**Subject: Beaver Valley Power Station, Unit No. 2
Docket No. 50-412, License No. NPF-73
Response to a Request for Additional Information in Support of
License Amendment Request No. 183**

FENOC RESPONSES TO REQUEST FOR ADDITIONAL INFORMATION
LICENSE AMENDMENT REQUEST FOR REVISED STEAM GENERATOR
INSPECTION SCOPE (F* CRITERION)
FIRSTENERGY NUCLEAR OPERATING COMPANY
BEAVER VALLEY POWER STATION UNIT 2
DOCKET NO. 50-412

Figure 1

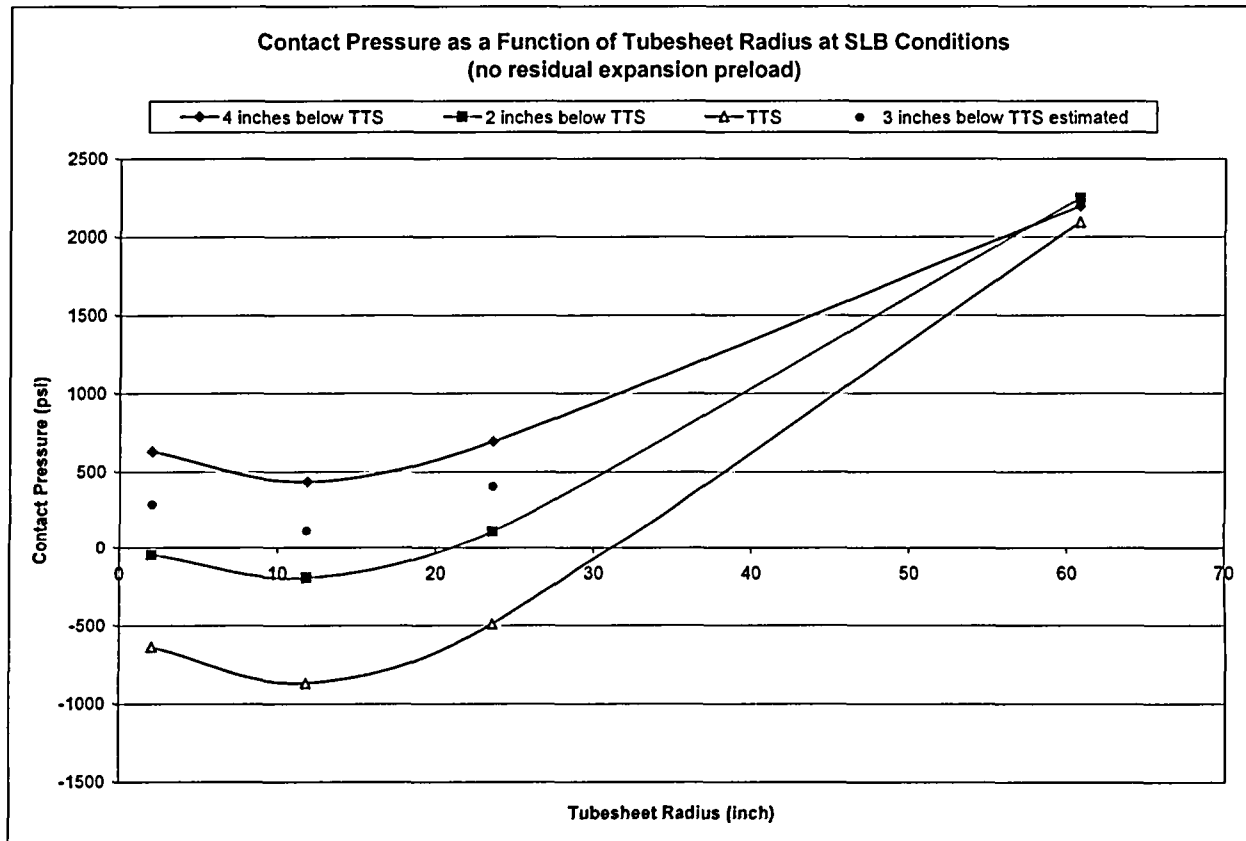
1. The staff was unable to determine the extent to which the leak test results in WCAP-14697 considered the effect of tubesheet bow. As a result, it is not clear to which tube locations these data would apply. In addition, although the leak rates for the test data in WCAP-14697 were low, numerous tubes could have flaws that go undetected with your proposed inspection extent. This could result in an unacceptably high amount of leakage when all tubes are considered.

Given the above, please provide additional justification for your methodology for assessing accident induced leakage for the region of the tube that will not be required to be inspected by the proposed technical specifications. For example, address the number of tubes that could be affected by degradation at the end of your current licensed period of operation, the axial elevation of the degradation in these tubes (if not assuming all tubes have degradation at the location where the inspections are no longer performed), and the severity of the degradation (if not assuming a 360-degree through-wall flaw). Please provide the technical basis associated with the above if you are not assuming all tubes have 360-degree through-wall flaws at the end of the inspection distance.

At 3 inches below the top of tubesheet, neglecting residual effects of the roll expansion, the tubesheet bow contact pressure reduction is slightly overcome by the thermal and pressure growth for all tube locations (see Figure 1). Thus, when the residual expansion process effects

are considered, all tubes will retain contact pressure equal to or greater than the contact pressure associated with the expansion process, or approximately 3800 to 4000 psi. This comparison considers the limiting radial location on the tubesheet. At this contact pressure primary to secondary leakage at MSLB conditions is not anticipated; thus, there is no basis to assume postulated indications below the F* inspection distance would contribute to leakage. From Figure 1 it can be seen at the 30 inch radius location and 3 inches below the top of

tubesheet, the total tube to tubesheet contact pressure is approximately 4500 psi and far exceeds the MSLB condition maximum driving pressure of 2560 psi. About 75 percent of the tubes reside outside of the 30 inch radial location.
